**TOWN OF NEWBURGH  
PLANNING BOARD  
TECHNICAL REVIEW COMMENTS**

**PROJECT NAME:** DRIVANOS- 2 LOT SUBDIVISION/LOT LINE CHANGE  
**PROJECT NO.:** 2024-09  
**PROJECT LOCATION:** SECTION 2, BLOCK 1, LOT 14 & 15  
**REVIEW DATE:** 28 OCTOBER 2024  
**MEETING DATE:** 7 NOVEMBER 2024  
**PROJECT REPRESENTATIVE:** ZEN CONSULTANTS

**LANDS OF QUAKER PROPERTIES, LLC**  
2 LOT SUBDIVISION  
**LAYOUT PLAN**  
SBL: 2-1-15  
TOWN OF NEWBURGH, ORANGE CNTY.

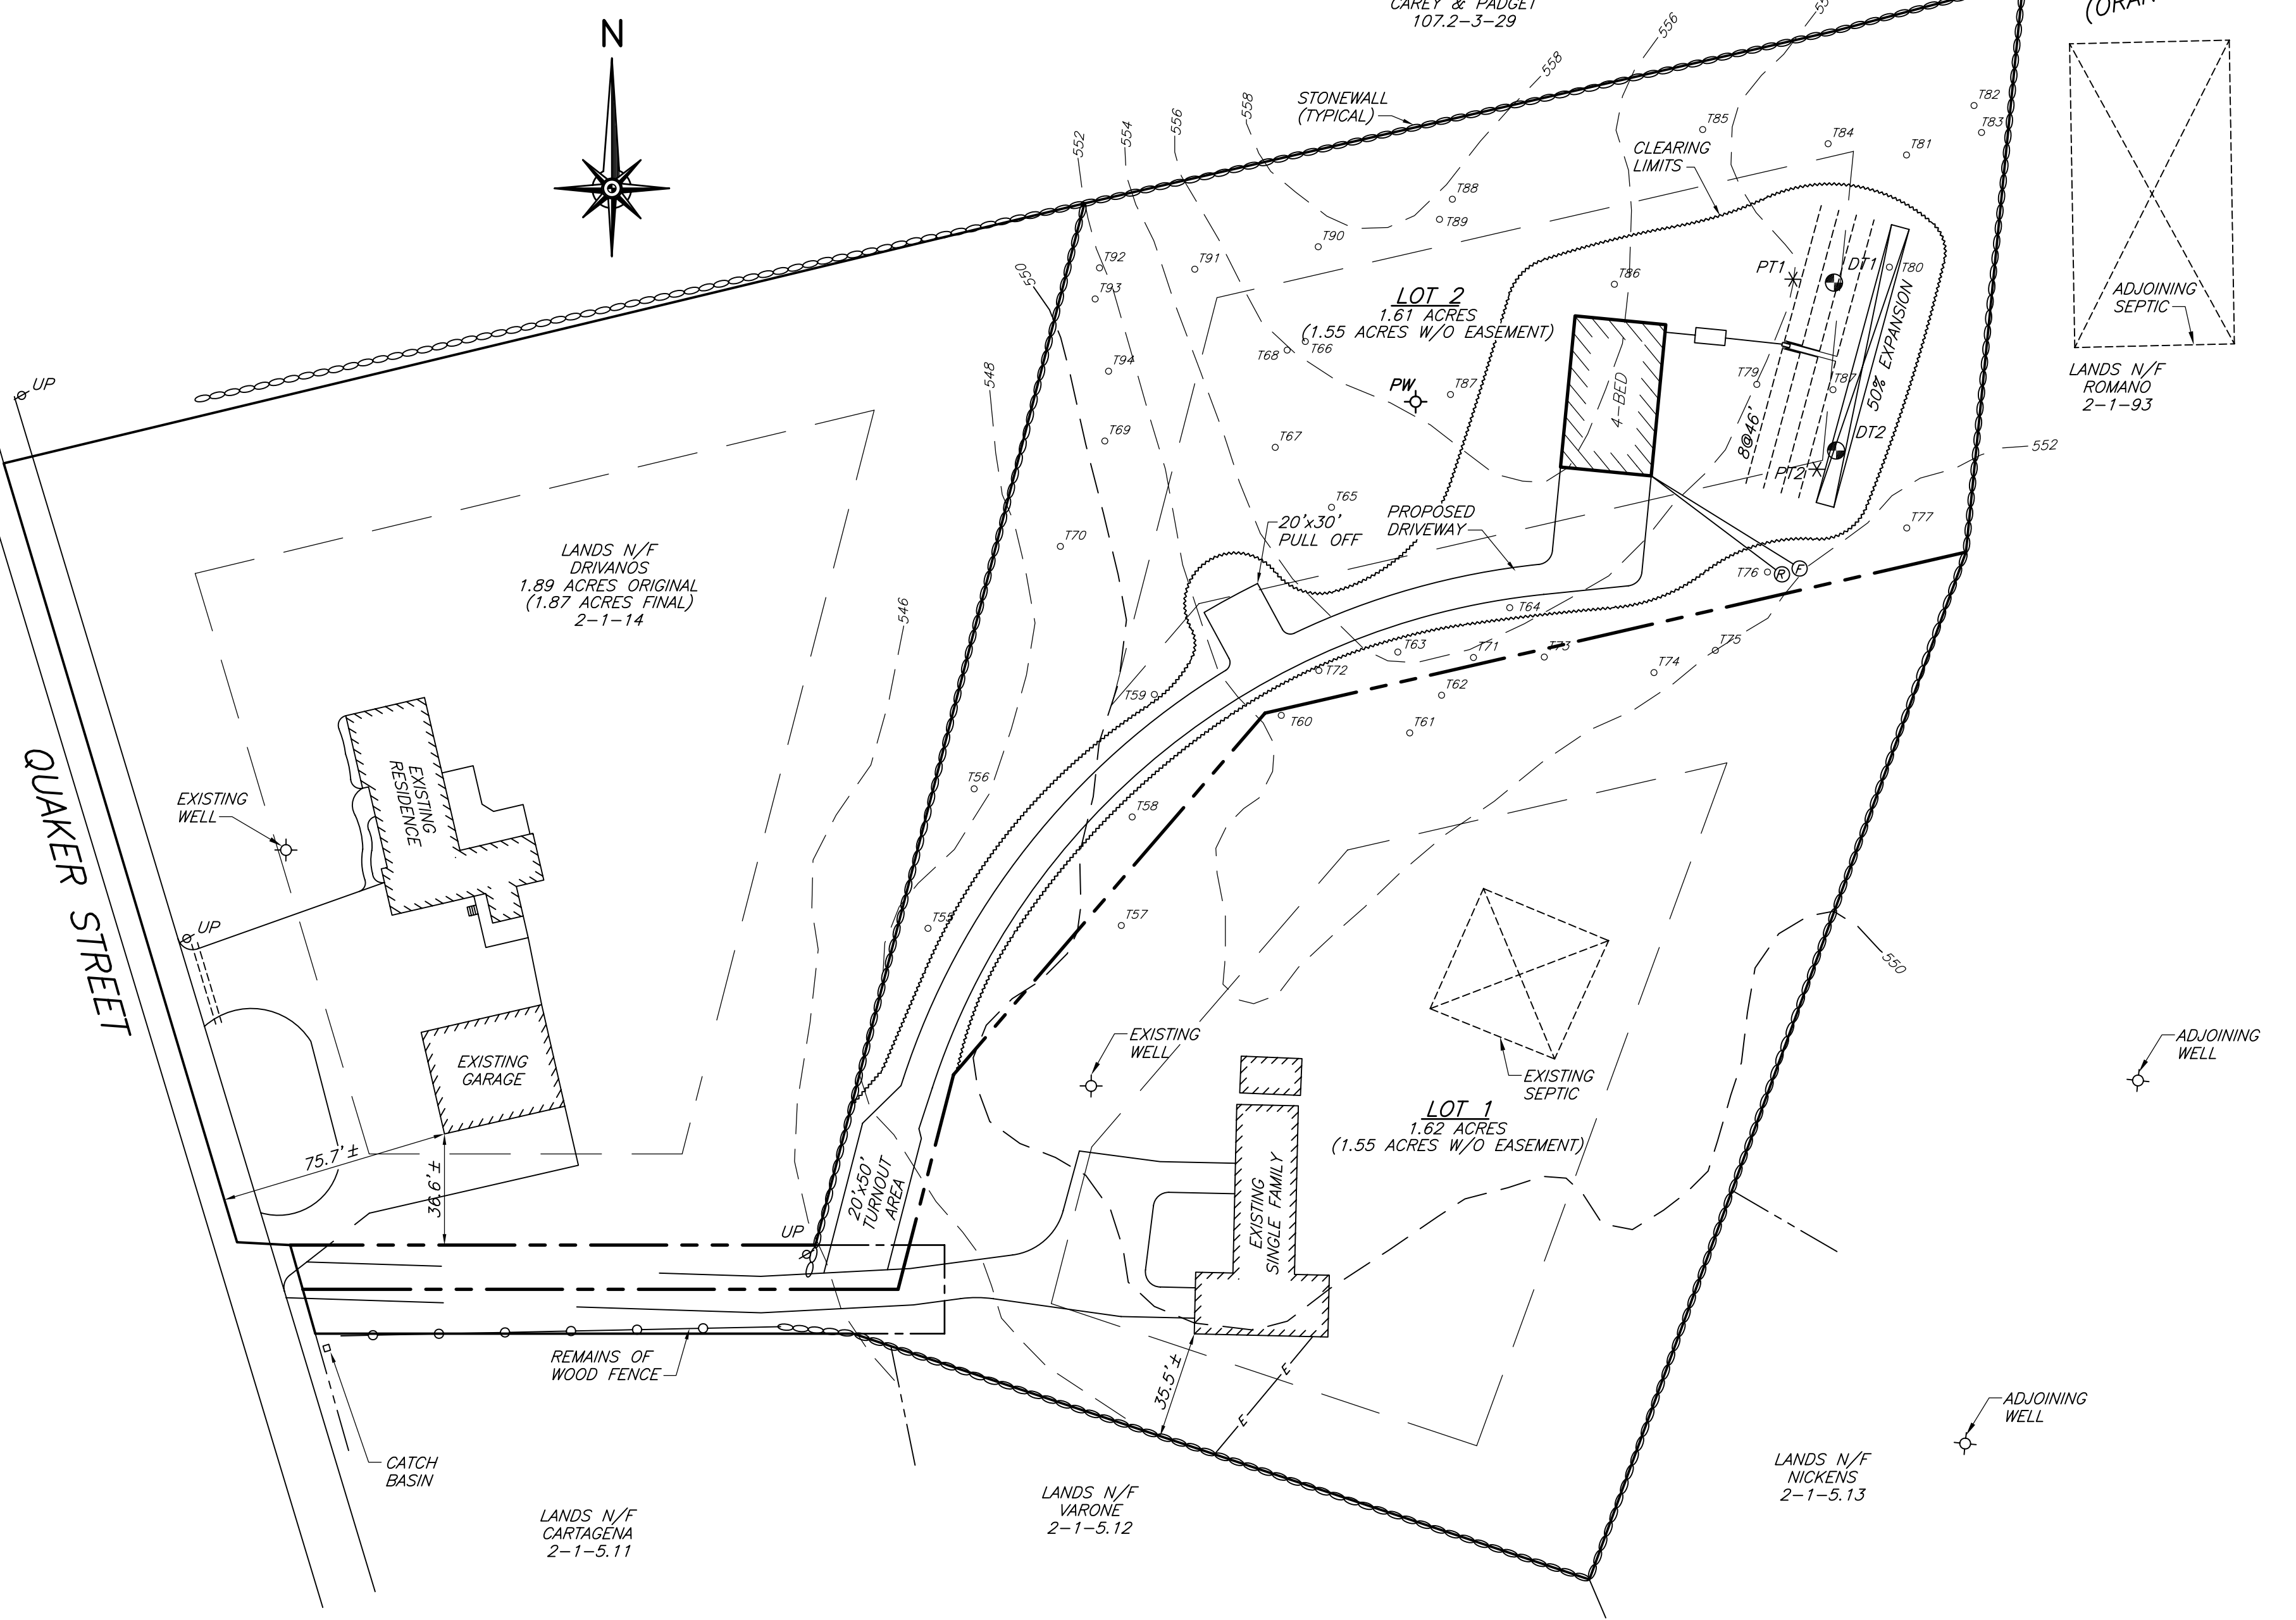
1. An Common Driveway Access and Maintenance Agreement will be required to be filed as a condition of any approvals.
2. Orange County Planning has issued a Local Determination and project was submitted to the Plattekill Planning Board.
3. The applicants' representative are requested to label the limits of disturbance to show disturbance is less than one acre for the two lot subdivision. (One new lot)
